10 Flood risk, groundwater protection, geology and land contamination (Fg.2)

Flood risk and drainage

ES Appendix 11.3 Road Drainage Strategy [APP – 281], Figure 5.2 Blick Mead Drainage Catchment Comparison,

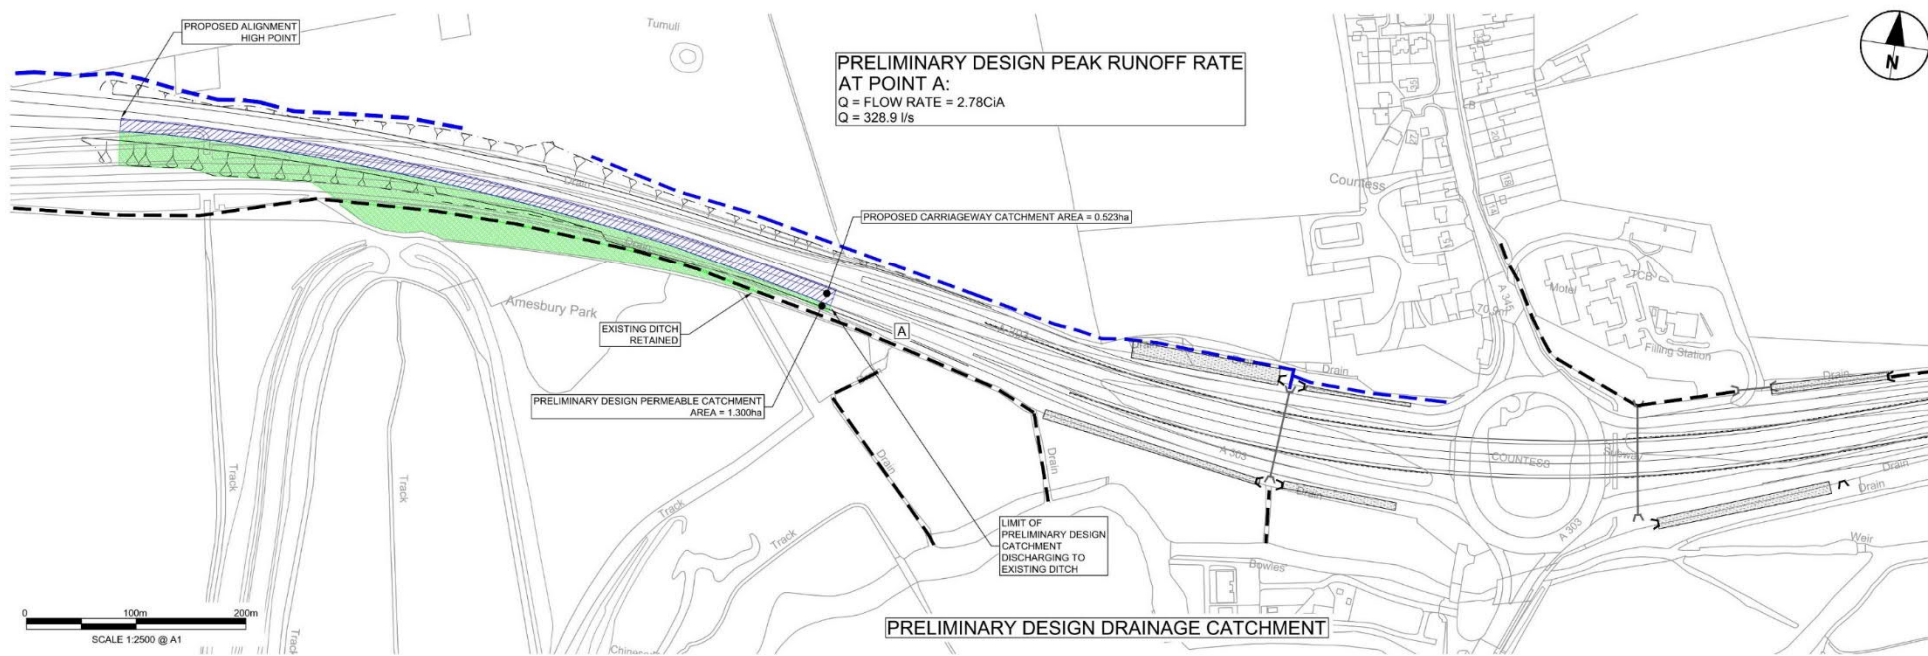
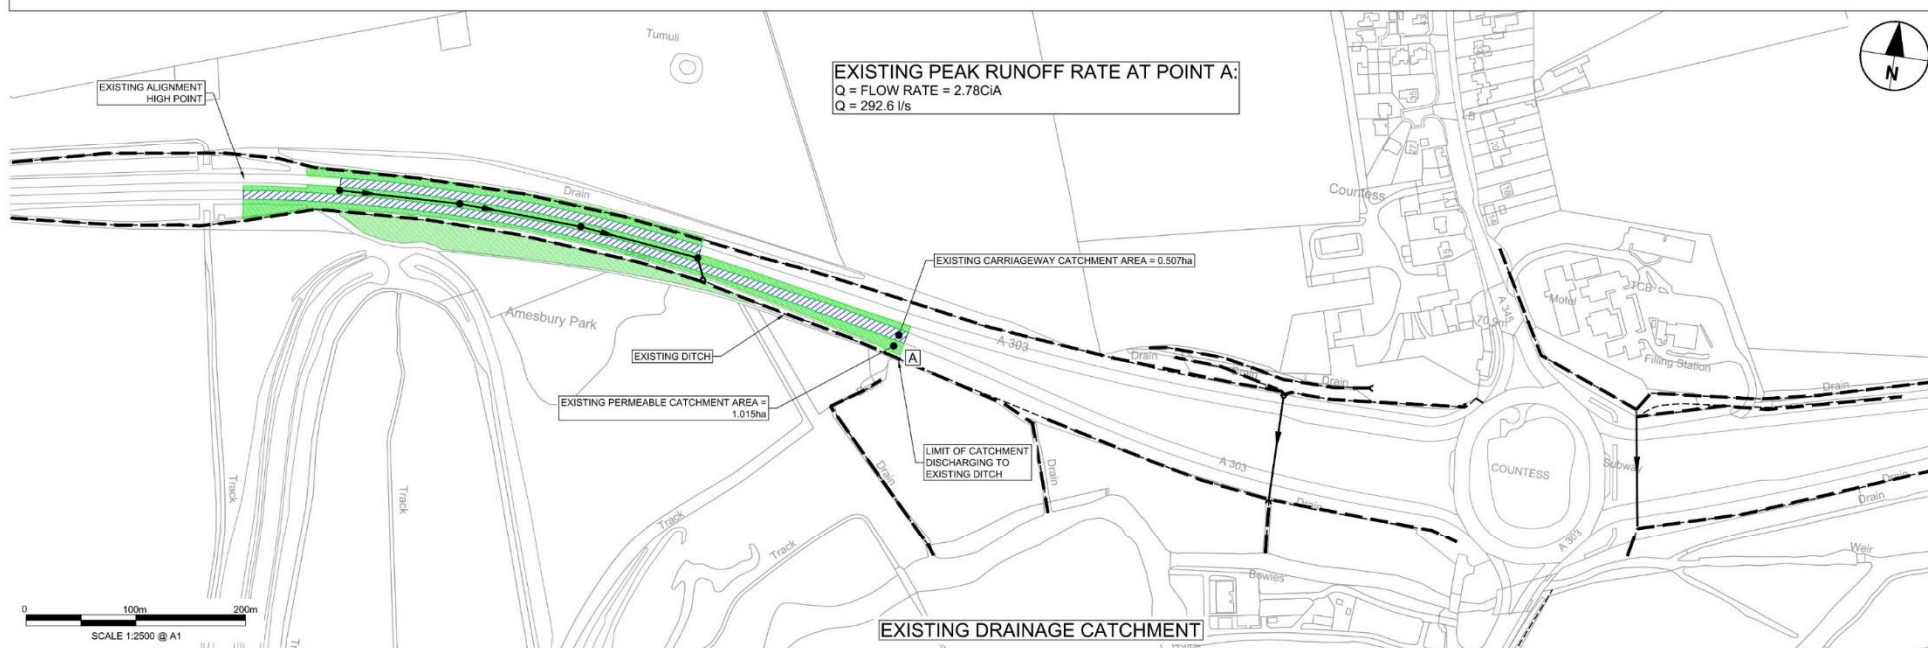
Figure 5.2 in the Road Drainage Strategy [REP2-009] sets out a catchment comparison for Blick Mead. It shows an existing and preliminary proposed peak flow rate.

- i. Can you please explain the numbers in this figure and in particular what the second Q number represents and why this rises in the proposed preliminary design?
- The drawing, Figure 5.2, ES Appendix 11.3 Road Drainage Strategy, illustrates the catchment areas contributing to the surface water discharge at the peak runoff rate, calculated with the Modified Ration Method, for the existing highway and post construction of the Scheme at a location identified as “A” within the existing ditch at Blick Mead.
 - Q** is the flow rate, measured in litres per second, based on,

A is the contributing area
 - The flow rate **Q** is the summation of the flows from the impermeable area (shown hatched blue on Figure 5.2) and the permeable area (shown dense hatched green on Figure 5.2)

- ii. **In addition, please provide a clearer copy of this figure as the text is difficult to read.**
7. A copy of ES Appendix 11.3 Road Drainage Strategy [APP – 281], Figure 5.2 Blick Mead Drainage Catchment Comparison, can be found in Appendix A.
